**CONDITIONAL APPROVAL
PLAN APPROVAL EXPIRES: 08/30/2015**

Holy Rosary School
N6217 County Rd V
City of Durand, 54736
Pepin County

Facility: 608700 HOLY ROSARY SCHOOL
N6217 COUNTY RD V
DURAND 54736
Plan Type: Addition-Alteration; 1 Interior Fixture(s)

Object Type: Commercial Water Treatment Device Regulated Object ID No.: 1397381

DWG #		H125-NRS-20 TWIN w/ pH CORRECTION	
73-H125-NRS-40-TV			
8-9-13			
dwg by: J.WAACK		Waunakee, WI 53597	
Approved by: J. McDONALD		(608)849-3050	
Engineer:		Engineer:

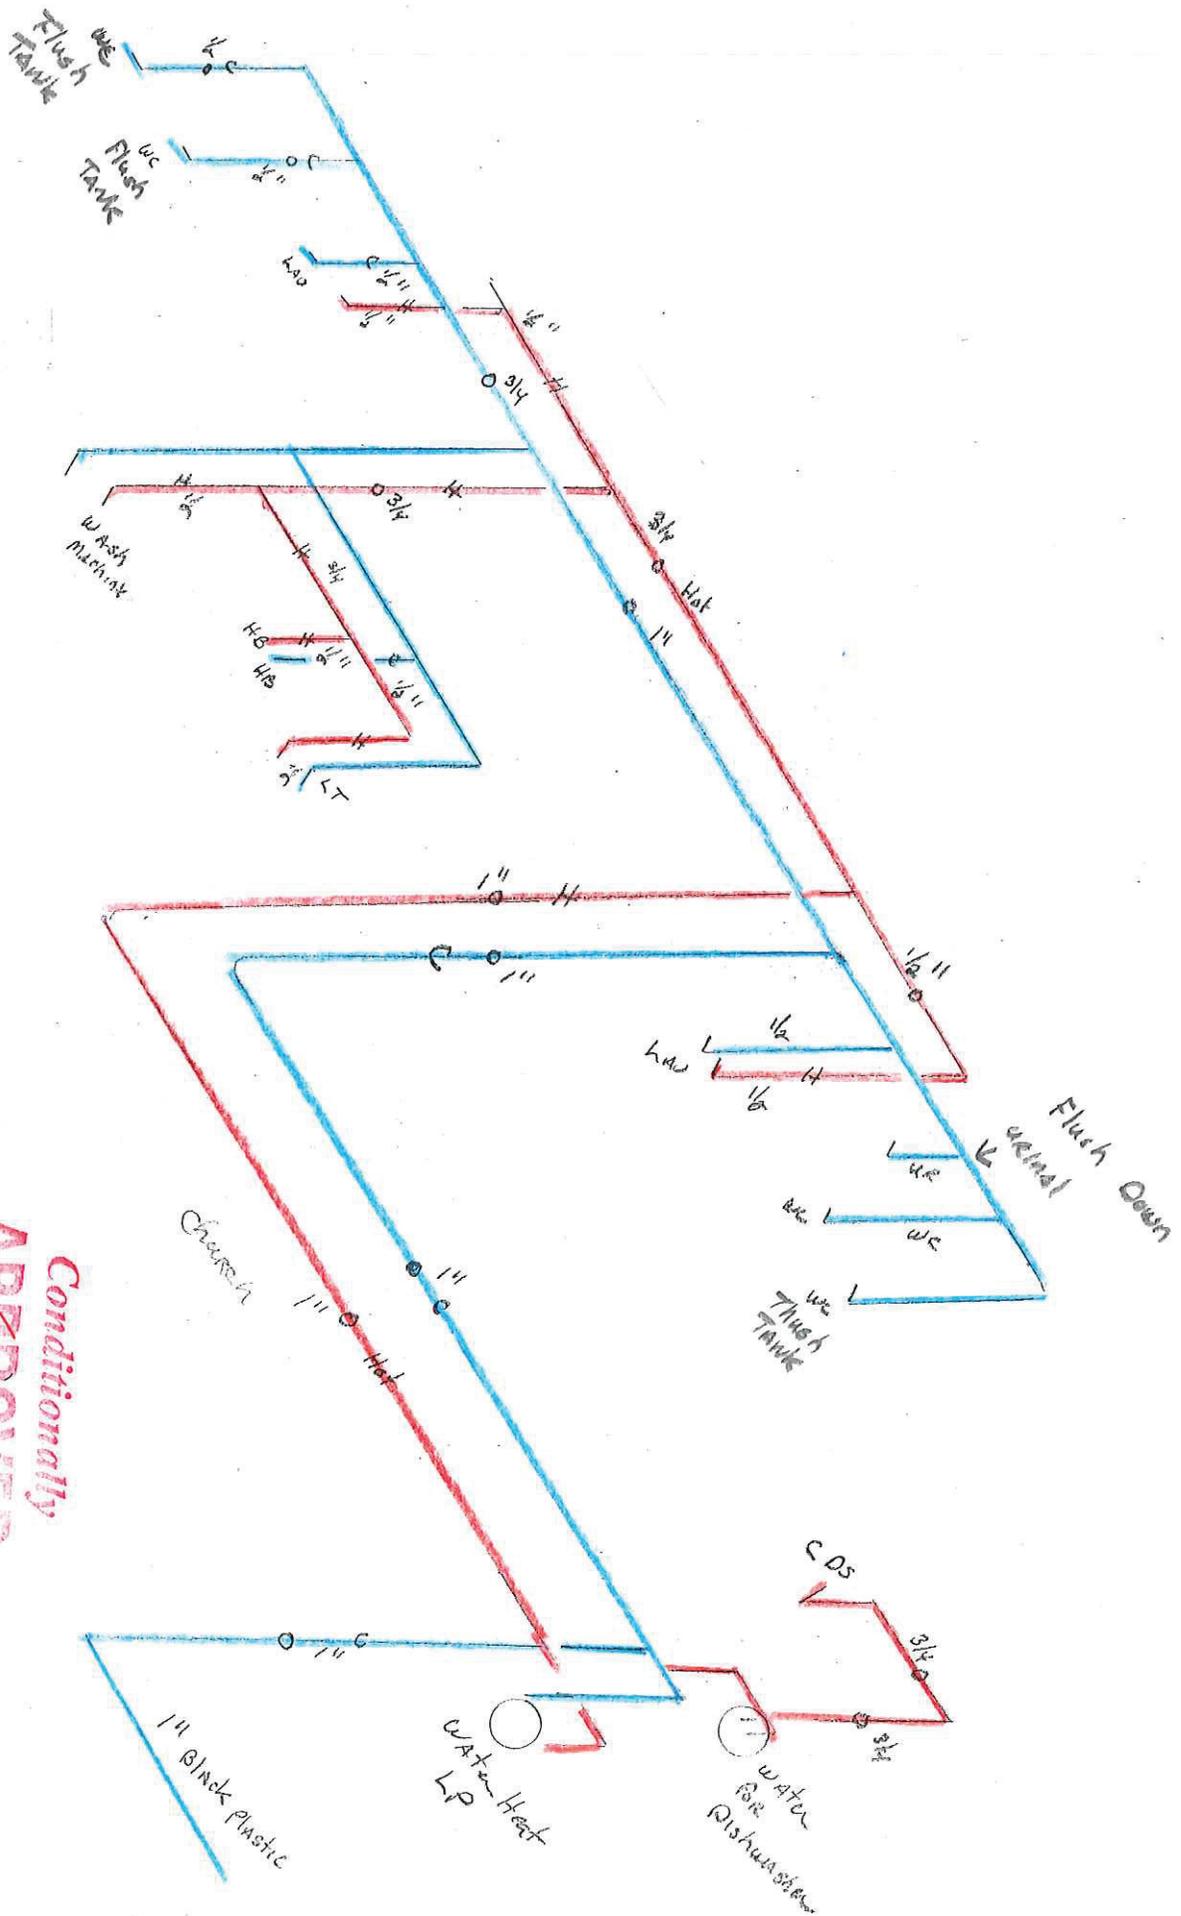
NO BYPASS VALVES PERMITTED

TWIN PARALLEL
BALANCED HEADERS
MUST BE INSTALLED

ELECTRICAL BONDING JUMPER
IF NECESSARY.

INTERCONNECT PIPING PROVIDED BY INSTALLER
ALL DIMENSIONS +/- 2"
